5722 APARTMENTS

SDCI Project #3036025-LU

Recommendation Meeting | REC
Southeast Design Review Board

1.C VEHICULAR AND PEDESTRIAN ACCESS ROUTES

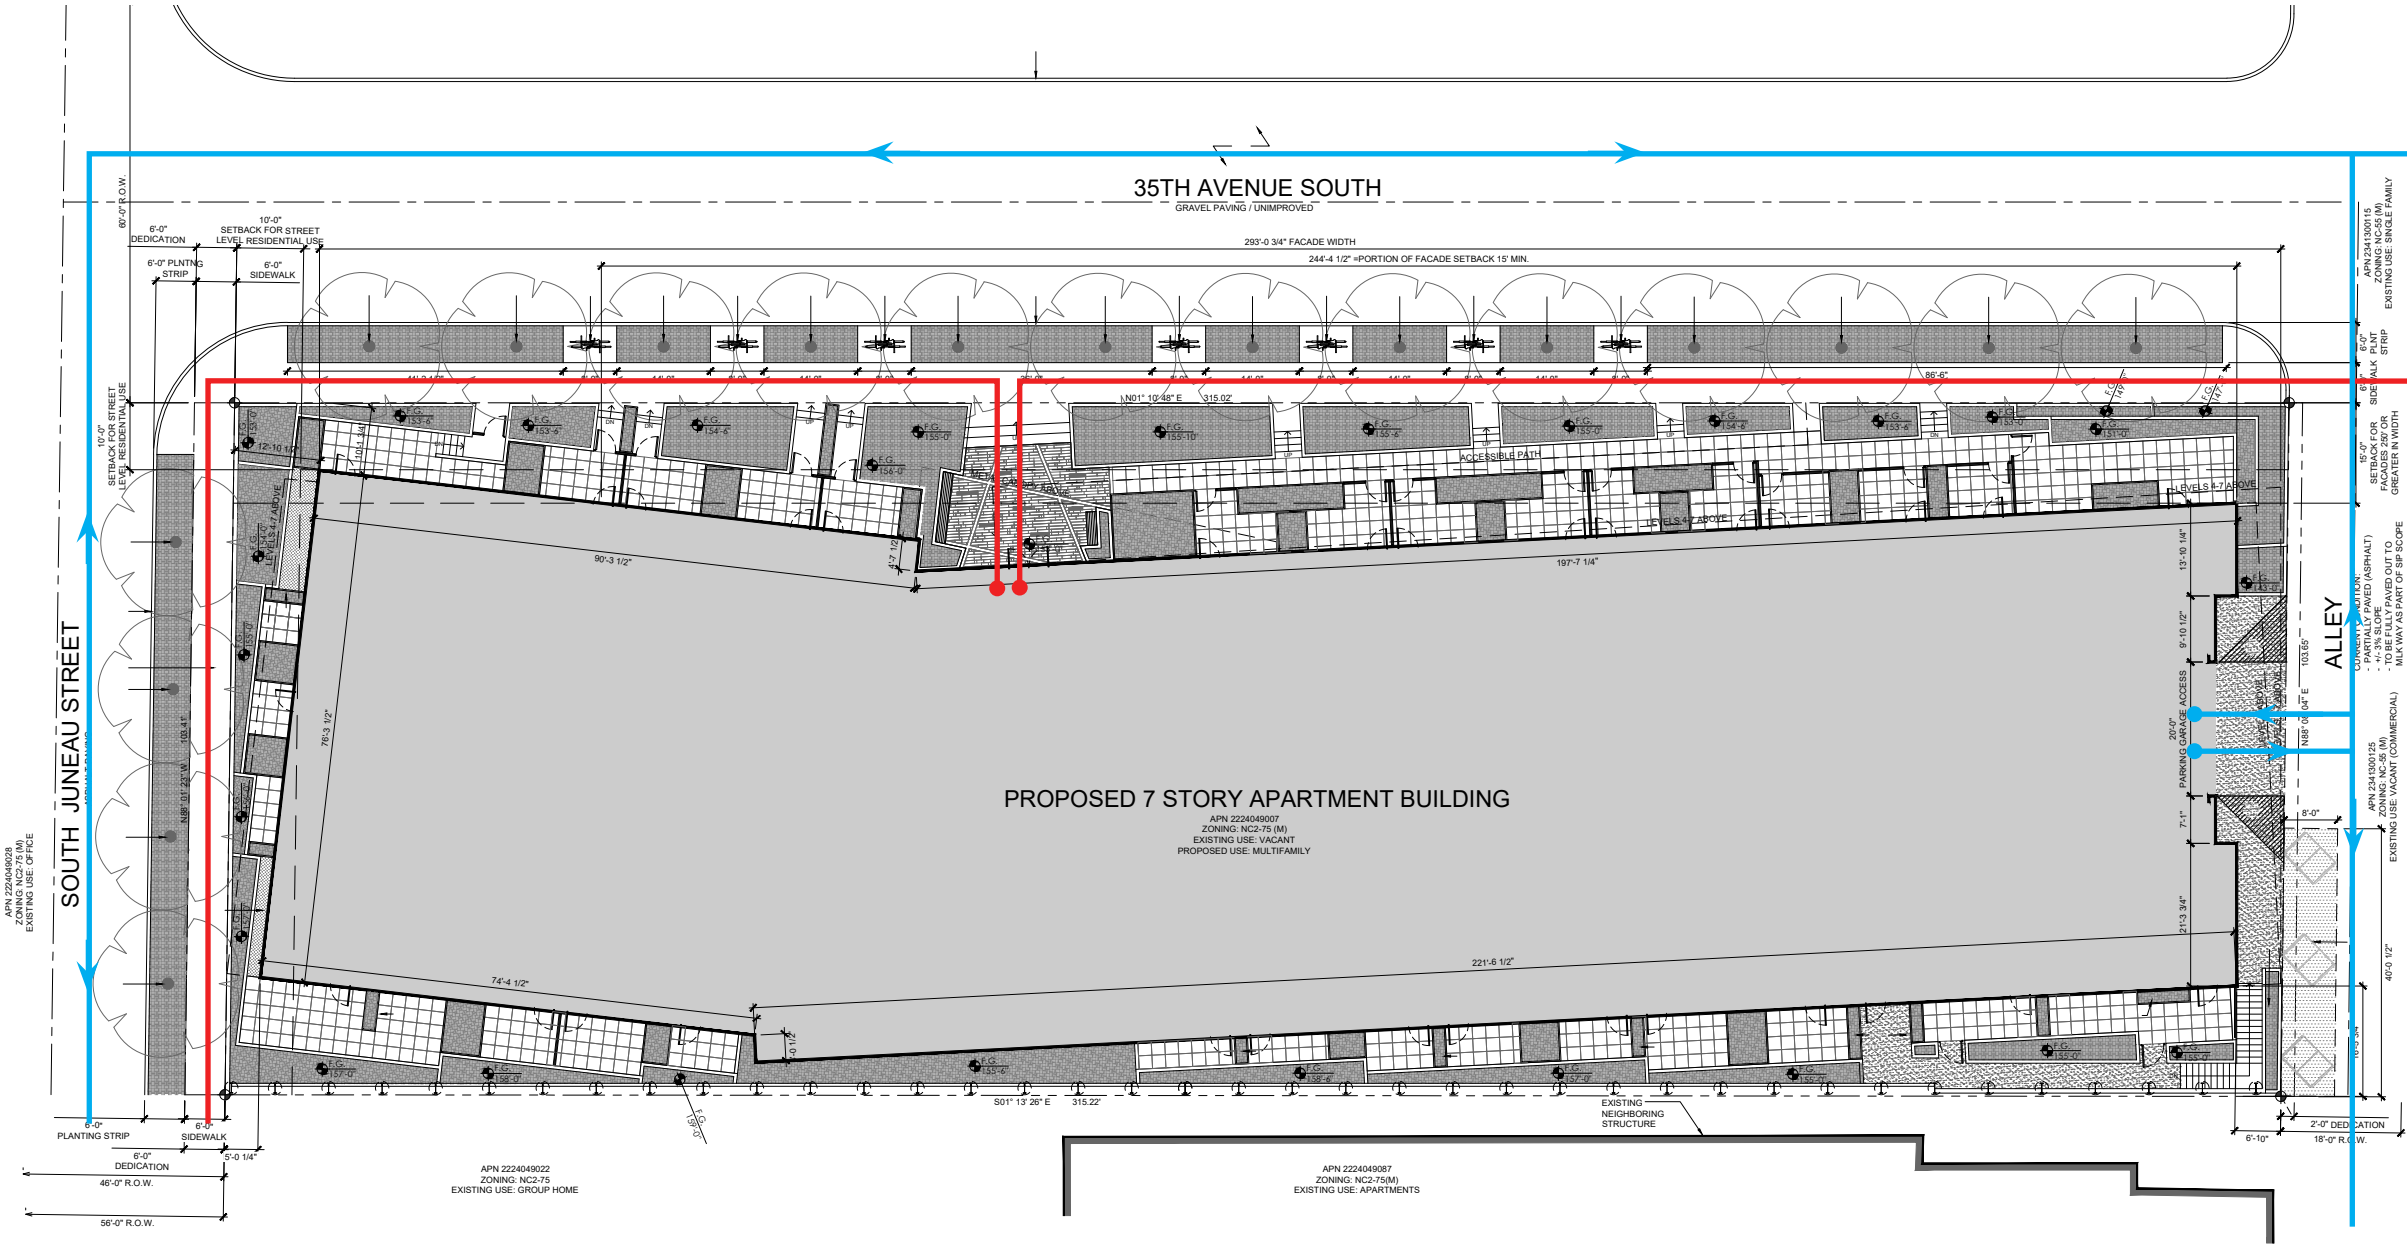
- a. All Board members cited positive aspects of Concept 2. There was not complete agreement on the other options.
- i. Some Board members expressed an appreciation for Concept 1 and the generous and consistent buffer. Not all Board members agreed specifically in EARLY DESIGN GUIDANCE #3033854-EG Page 4 of 16 regard to the mid-block plaza as a potential barrier to activation. (PL1, PL2 and DC3-B)

- ii. The Board described Concept 2 as having the best of both worlds with a continuous ground plane to set up a connection to the street and a generous pull back that creates an entry plaza that could be activated with seating or other uses. (CS2-B and PL3-2)

- b. The Board suggested highlighting the new part of SW 35th as a more pedestrian area. They informed the applicant that they would be willing to support traffic calming features on this side if SDOT agrees. (DC-1B)

- c. The Board stated that more clarity around the hierarchy within the design will be required, specifically regarding how the proposal will separate vehicular and pedestrian access. (DC-1B)

The design has been developed based on the Concept 2 shown in the EDG package according to the board’s comments. The generous setback and the continuous ground plane along the 35th Ave South are provided to promote a natural flow of pedestrian circulation, create a connection to the street and activate the street front. The generous set back also provides an area for the private patio spaces for the units as well as ample landscaping and pedestrian sidewalk area. All of these have highlighted the residential character of 35th Avenue. The extra pull back at the main entry also creates a plaza that will be furnished with seating and pavers integrated with public art.

As shown in the diagram, there is clearly separated access for pedestrians and vehicles. The pedestrians enter the building entrance located along 35th Avenue, which is buffered by landscaping and street trees from the vehicles. Vehicles will enter the building through the garage entrance from the alley located at the north end of the property.

1.PAVER AT ENTRY PLAZA / ARTWORK

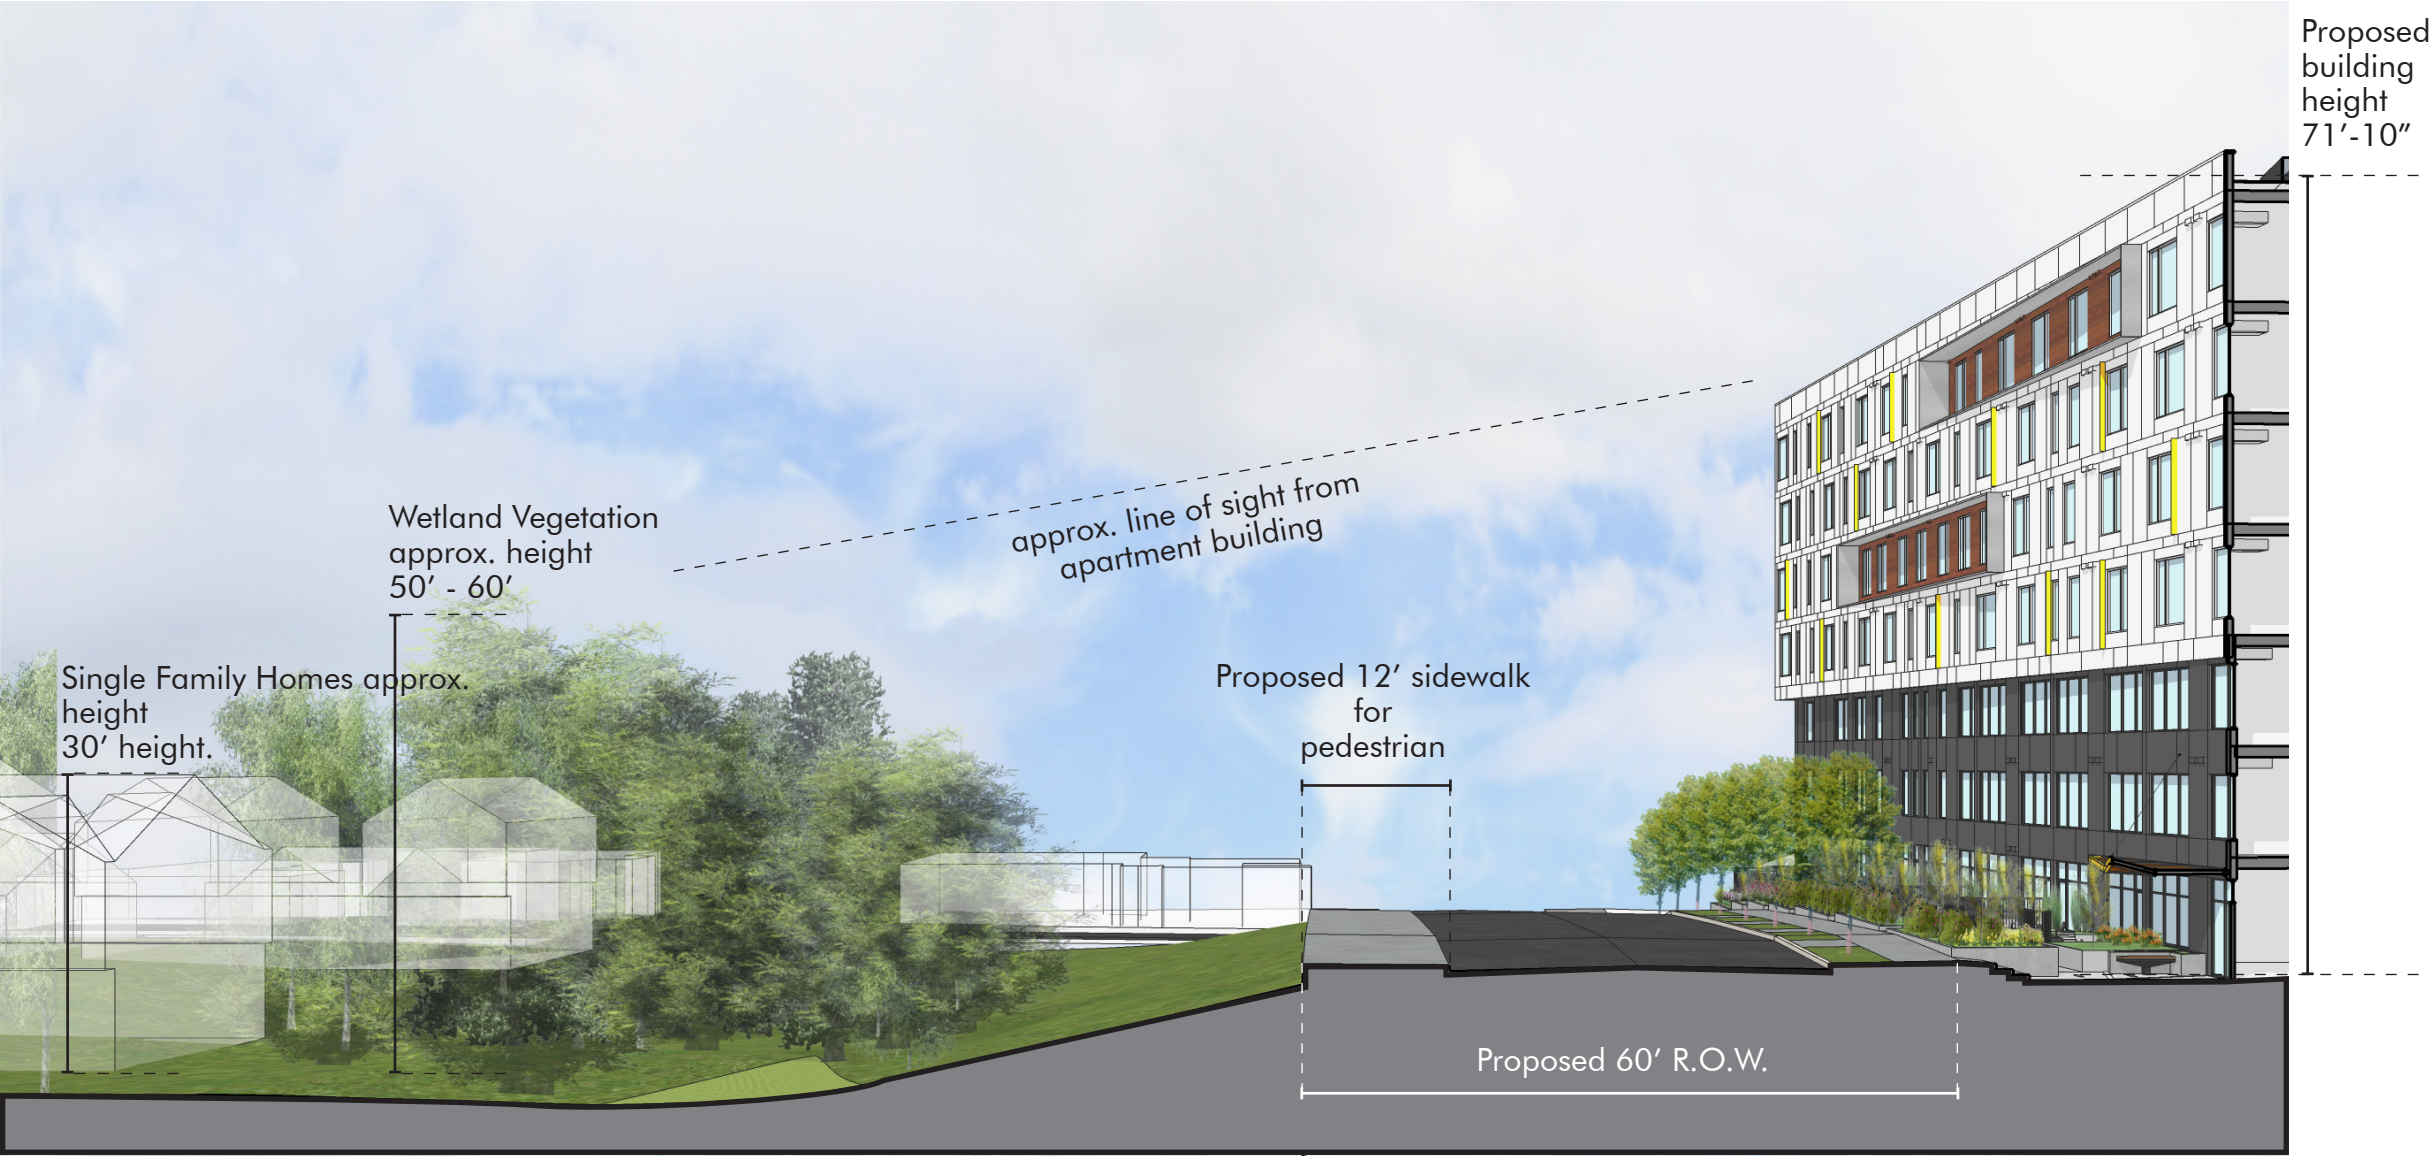
- d. The Board requested an exploration of artwork as a way of activating public space, including but not limited to in the hardscape on the buildings or at the entrances. Information about the artist's portfolio and conceptual artwork options for review will suffice at the Recommendation meeting. (CSB-3)
- e. Board members reminded the applicant that expected to see a lighting plan at the recommendation phase and underlined its importance evaluating how well the project meetings design guidelines. (PL2-I-ii.)

The proposed design incorporates artwork in multiple locations through various medias, which include on the building entry canopy, integrated into the entrance plaza pavers and on the north building corner entering the development. The artwork on the building entry canopy glass provides sunshade and brings attention to the building entrance to make it stand out from the surroundings. The artwork incorporated into the pavers at the building entry public plaza, which are different languages of "HOME" by local artists, inspired by the "O! Hello Othello!" project by Onboard Othello, is a fun representation of the cultural diversity in the Othello neighborhood. It also brings the human scale and interest to the space while activating the plaza at the same time. The artwork is placed on the north corner of the building along 35th Avenue S and provides signage and wayfinding for the public and residents.

MULTIPLE COLORS USED TO BREAK MASSING

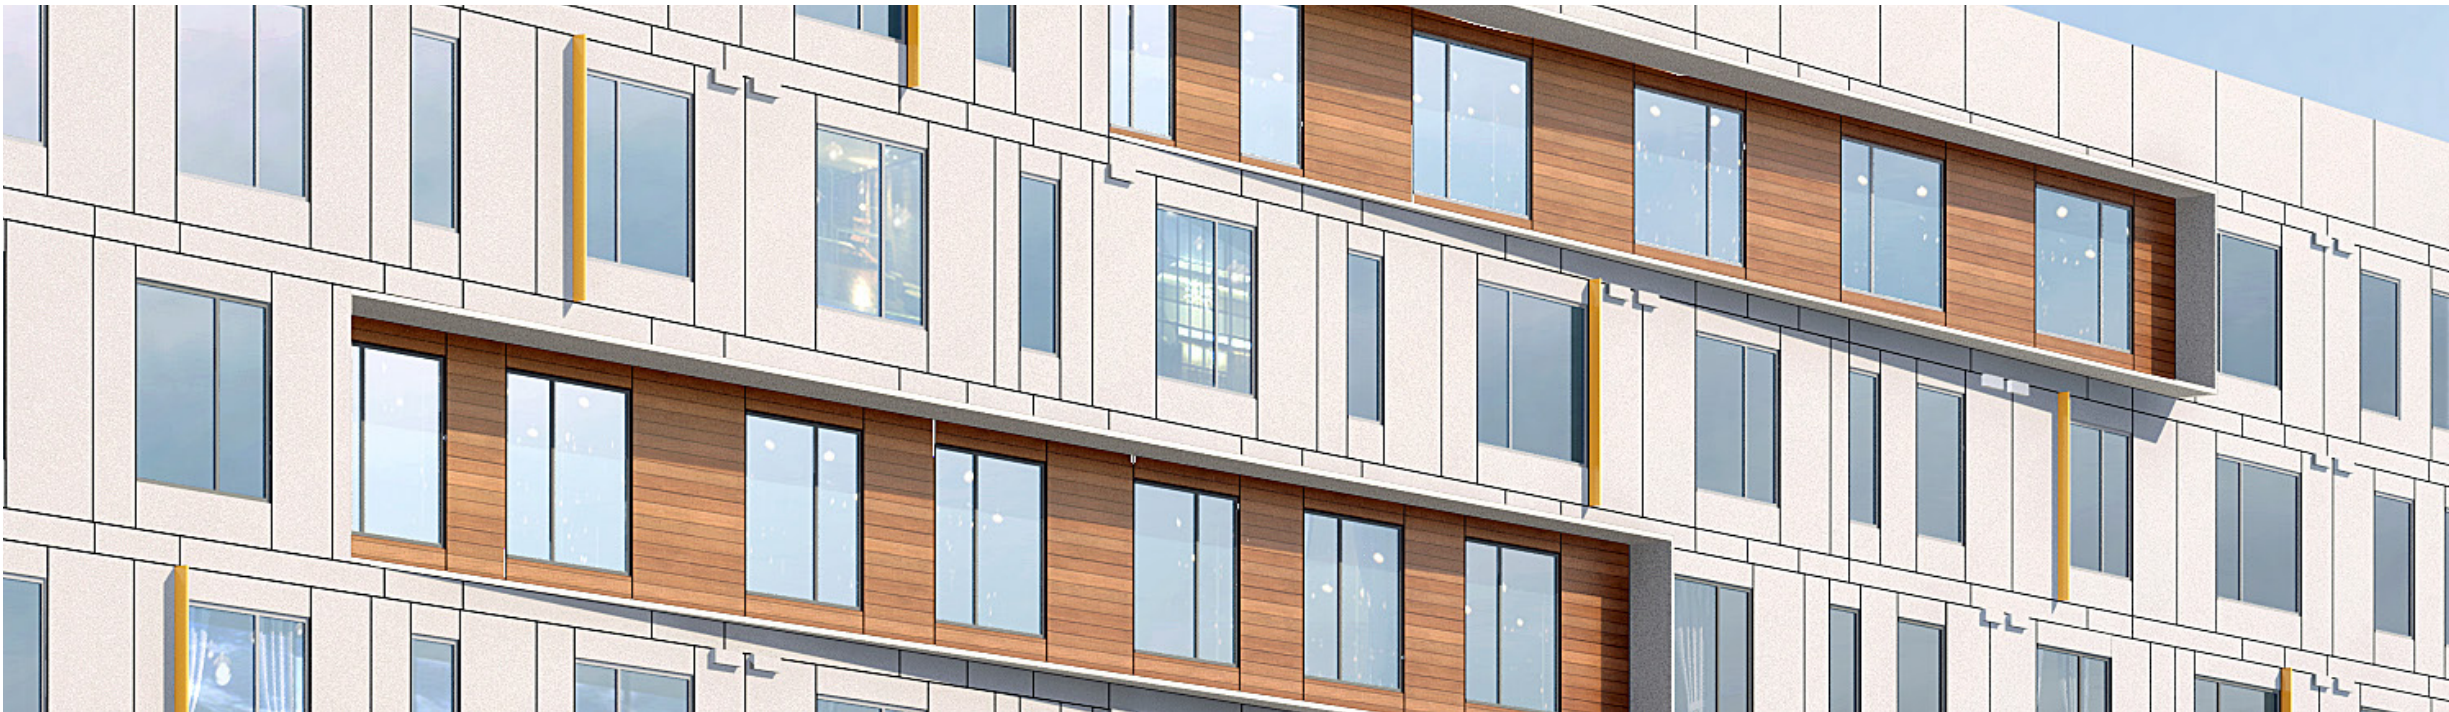
- iii. The Board stated that Concept 1 had positive attributes, including the safety, walkability and transition provided by this option. There was not agreement that this was, in and of itself, a preferred option. (PL-3)

- 1. The Board unanimously agreed that consideration of the buffer on the east side should be taken. Maintaining the 30 feet setback on the north was suggested. They said slightly less was acceptable on the south side. They further stated that that the applicant should provide good graphics at the Recommendation phase of review that illustrate this location. (CS2-II and CS2-D)

- iv. The Board also stated Concept 3 had positive attributes with its public gathering spaces and setback at the base and top to create stoops and a lower scale. There was not specific agreement that Concept three was the preferred option. (PL-3-A-2)

- v. The Board suggested that vertical modulation should be explored on Concept 2 as a way of breaking up its mass and making it feel less stridently modern and monotonous. (DC2-A)vi. Expressing individual units through push and pull of the volume or punching windows was suggested as another potential way of softening option 2. (DC-2-B)

The proposed design followed the Board's recommendations and provides a generous setback on the east side. The north end has more setback than the south along this façade. The proposed design provides a generous setback at the base along 35th Avenue. Individual stoops and patios are provided to achieve the neighbourly feel and soften the ground plane. A few recessed angular moves are introduced to the facades break down the mass to make it feel less modern and monotonous. Warm wood look materials are used in these recesses to bring warmth to the material palette as well as human scale. The difference in the window treatments and patterns at the lower and higher levels add another layer of modulation to the facades. Moreover, the smaller mass of the building is expressed in a different color to be perceived as a vertical element. To further break down the mass and express the individuality of the masses, bright colored vertical metal fins are also added to both the west and east facades. This has added more texture and color to the façade.
